Of applications to Hawke's Bay
Regional Council for resource
consents to take and use
Tranche 2 groundwater

**EVIDENCE OF HILARY LOUGH
ON BEHALF OF HAWKE'S BAY REGIONAL COUNCIL
OVERVIEW OF WATER QUANTITY AND QUALITY EFFECTS
8 AUGUST 2022**

Figure 13: Tranche 2 applicants' farm locations, proposed augmentation discharge locations and key river flow monitoring sites

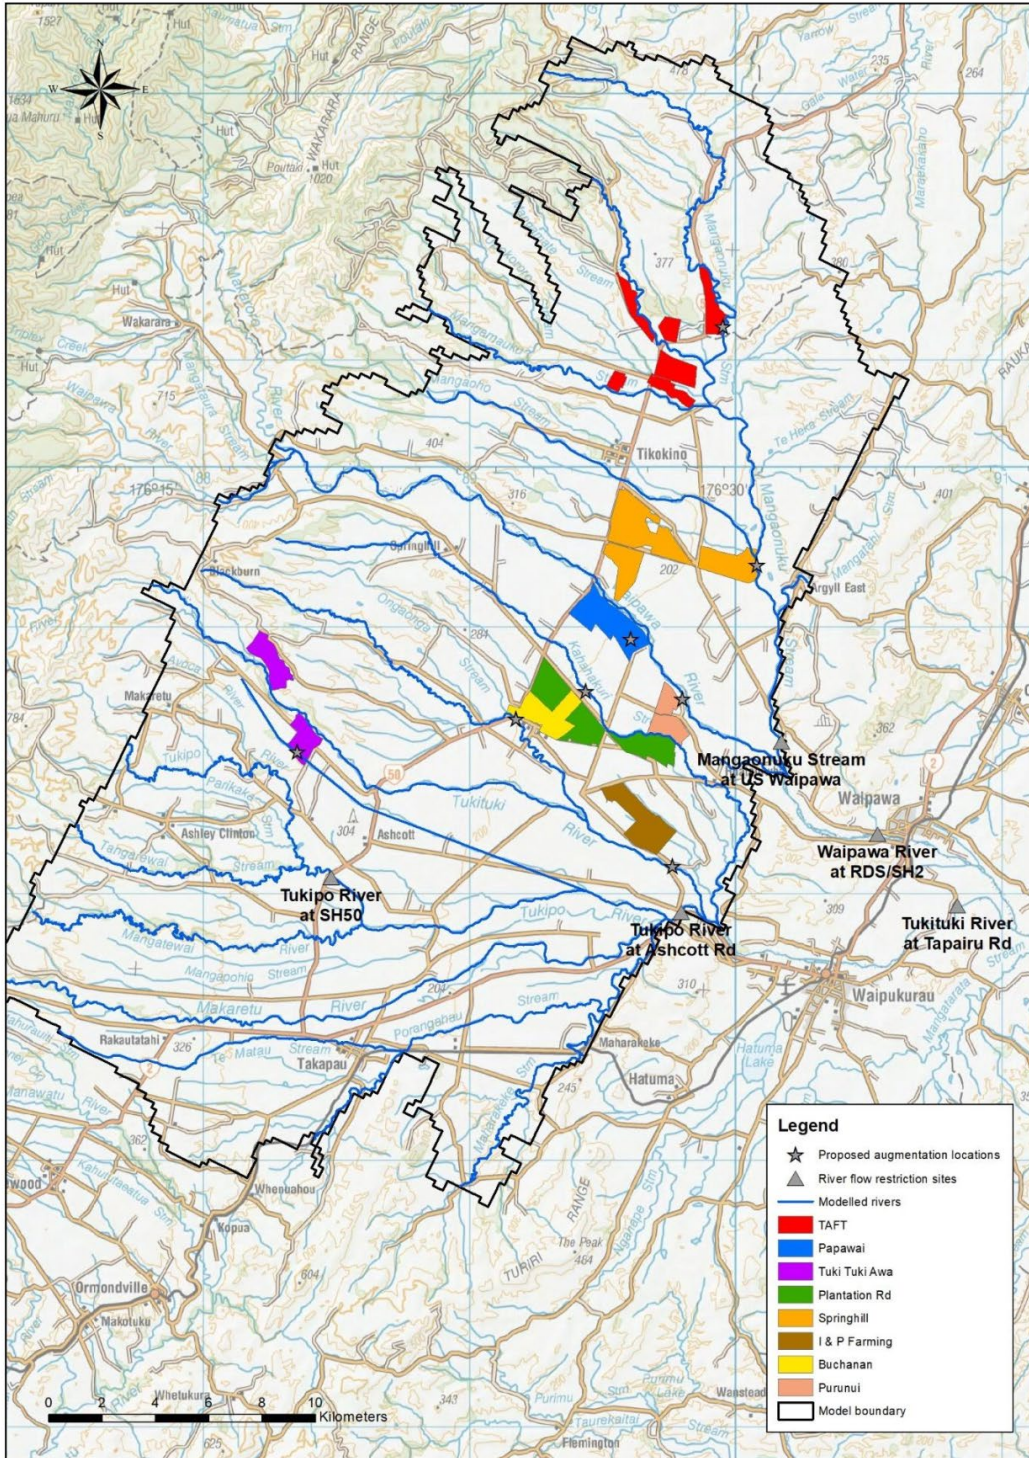
3.13 There are no proposed augmentation sites above the following flow management sites (although it appears Figure 13 from Weir (2022), which is reproduced below, may contain an error showing Tukituki Awa's augmentation site on a tributary of the Tukipo River, when the report describes and Figure 16 of that report shows discharge to the Tukituki River):

- 4.4** There are a large number of surface waterways that will experience flow depletion but will not receive augmentation water. In addition, reaches of streams and rivers upstream of the augmentation sites will experience depletion of flows. The augmentation sites proposed in Figure 13 (reproduced above) are all located near the applicants' properties.

- (a) **Issue – augmentation extent:** The augmentation site locations proposed in Figure 13 do not provide for any mitigation of depletion effects upstream of the discharge points or on other streams, rivers and wetlands. This may result in ecological impacts, as identified in the evidence of Ms Drummond, including loss of fish spawning habitat, loss of migration pathways for native fish, loss of watercourse connectivity, loss of habitat for fish and invertebrates, reduction in available hyporheic zone, mortality through drying or unsuitable water quality conditions, and degraded water quality as a result of reduced dilution capacity. The applicants have now modelled depletion effects for sites other than the main flow sites and assessed ecological impacts, but as outlined in the evidence of Mr Thomas and Ms Drummond, there are outstanding concerns on both the model uncertainty for depletion effects and the interpreted ecological impacts. I also note that there have been a number of assumptions made including around scaling of the predicted drawdown effects, lag times and perched streams in the ecological assessment (Keesing,
